service bulletin

No. 90-19

A. POSSIBLE DIFFICULTY SHIFTING OUT OF GEAR ON BRAVO DRIVE 1.36:1 AND 1.81:1

Bravo Drive Units 1.36:1 and 1.81:1 Gear Ratios Used on the Following Models: 502 Magnum, HP 465, D254

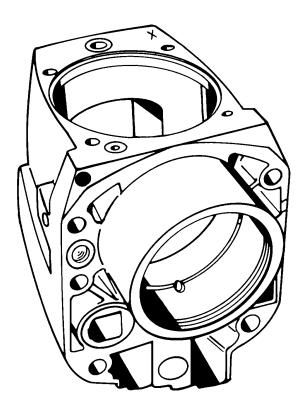
Bronze ring pressed onto upper and lower gears may come loose resulting in improper shifting, and difficulty in returning shift control to neutral may result.

Remove and replace both driven gears with new ones from service kit 43-815662A4. The new gears will be identified as shown in Figure 1 with an "A" next to the "+" (plus sign) on the bronze ring.

Order and install gear kit 43-815662A4

The drive shaft housing must be marked at two locations: on the left rear top corner under the top cover (A) with an "X", and on the right front surface (B) with a white paint dot 1/2" in diameter as shown in figure 2.
